HISTORIC AND DESIGN REVIEW COMMISSION

HDRC CASE NO: 2015-325
COMMON NAME: 531Brackenridge Avenue / Brackenridge Park Conservancy
ZONING: UZROW
CITY COUNCIL DIST.: 2
APPLICANT: RVK, Inc. / Kim Wolf
OWNER: COSA, COSA
TYPE OF WORK: Exterior Alterations - doors, windows, etc.
REQUEST:

The applicant is requesting approval to make the following exterior alterations at the Brackenridge Park Conservancy Office:

DEMOLITION PLAN
 BRACKENRIDGE PARK CONSERVANCY OFFICE
 1/8" = 1'

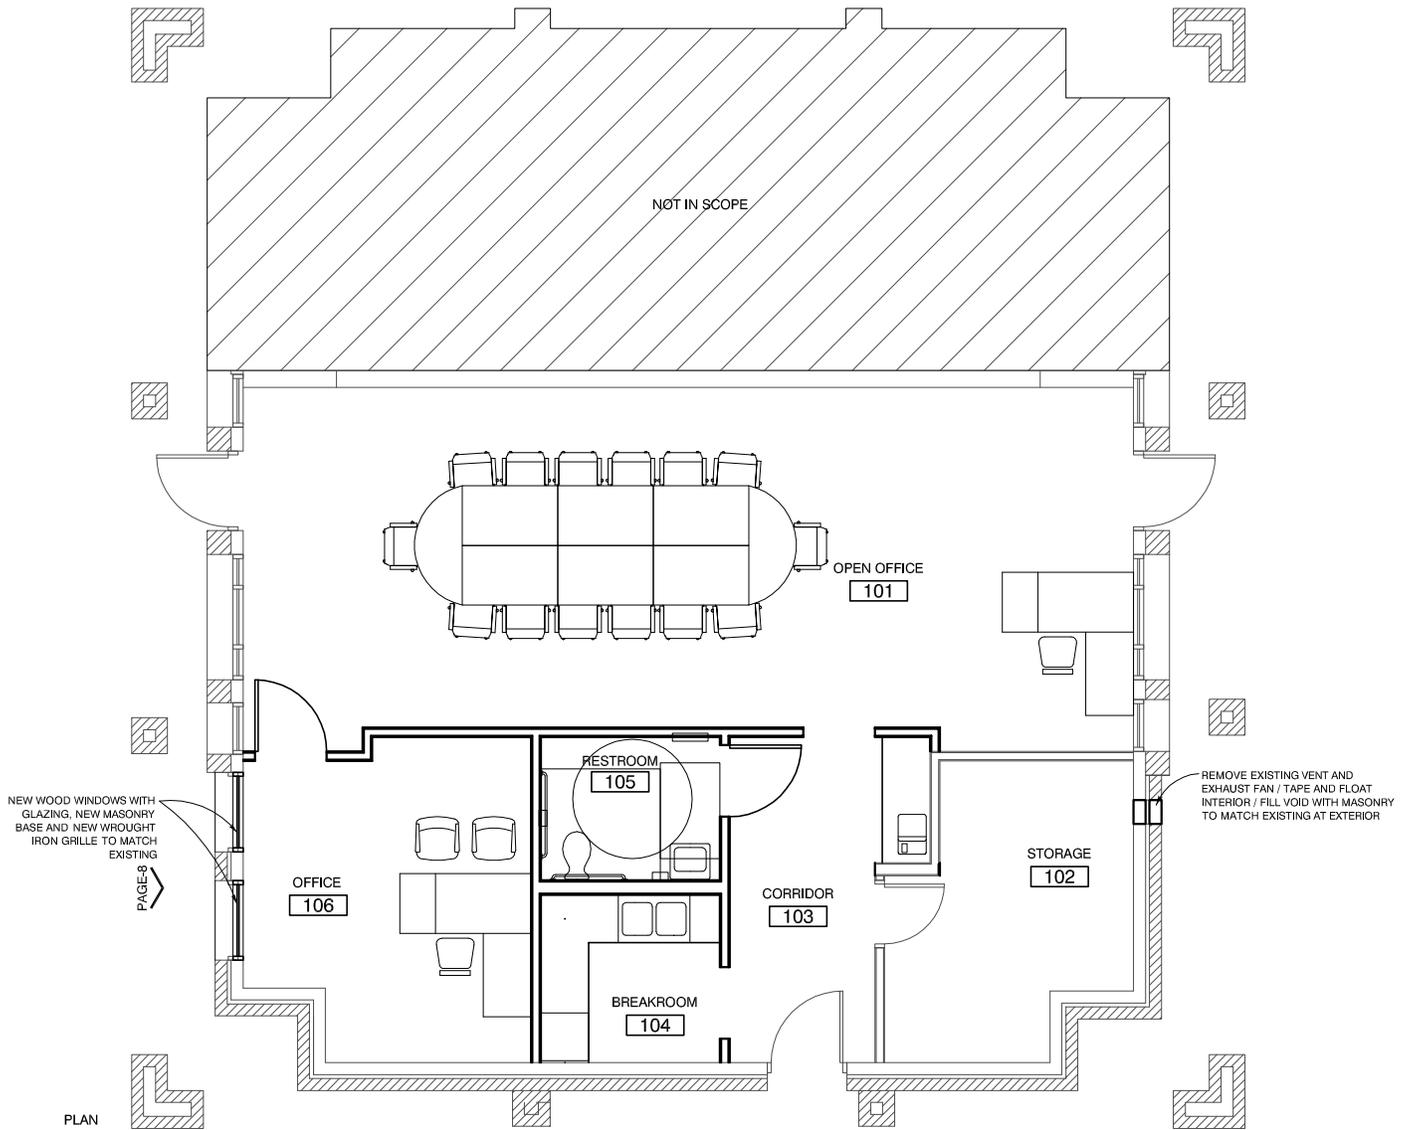
1. PREPARE ALL EXISTING WALL PARTITIONS IN AREAS OF CONSTRUCTION / PATCH, TAPE, FLOAT AND/OR TEXTURE AS REQUIRED TO RECEIVE NEW WALL FINISHES.
2. REMOVE, RELOCATE AND REINSTALL ALL EXIT SIGNS, AND FIRE EXTINGUISHERS THAT INTERFERE WITH NEW CONSTRUCTION (FIELD VERIFY) AS REQUIRED TO MEET BUILDING AND LIFE SAFETY CODES.
3. REMOVE EXISTING DOOR, DOOR FRAME AND DOOR HARDWARE COMPLETE / STORE PER OWNER'S REQUEST.

PHOTO 1: WEST ELEVATION

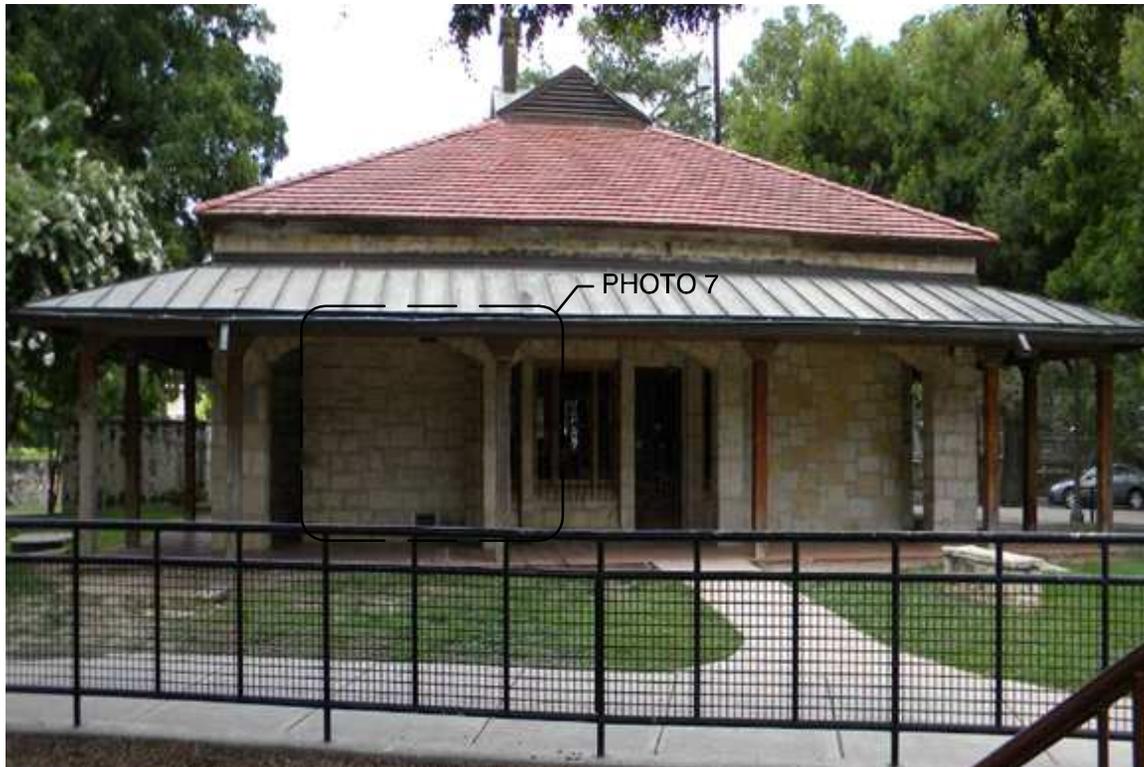
- REMOVE AND REPLACE SOLID HOLLOW METAL DOORS AND REPLACE WITH WINDOWS TO MATCH EXISTING
- REFER TO PHOTO 5 FOR ENLARGED EXISTING DOOR ELEVATION

PHOTO 7: EXISTING VENT AND EXHAUST FAN AT EAST ELEVATION

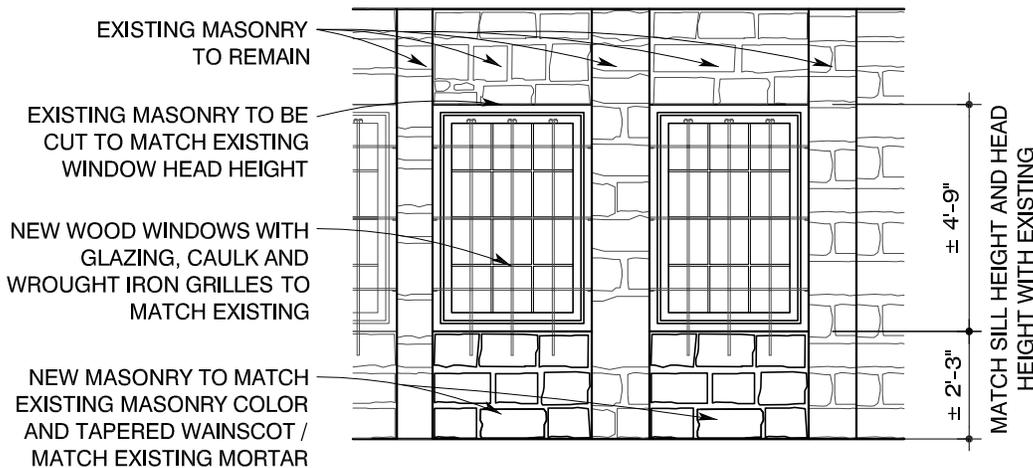
- REMOVE EXISTING VENT AND EXHAUST FAN / TAPE AND FLOAT INTERIOR / FILL VOID WITH MASONRY TO MATCH EXISTING AT EXTERIOR
- EXISTING VENT AND EXHAUST FAN ARE NO LONGER NEEDED OR IN USE / VENTS WERE USED TO SERVICE A PREVIOUS CONCESSION STAND
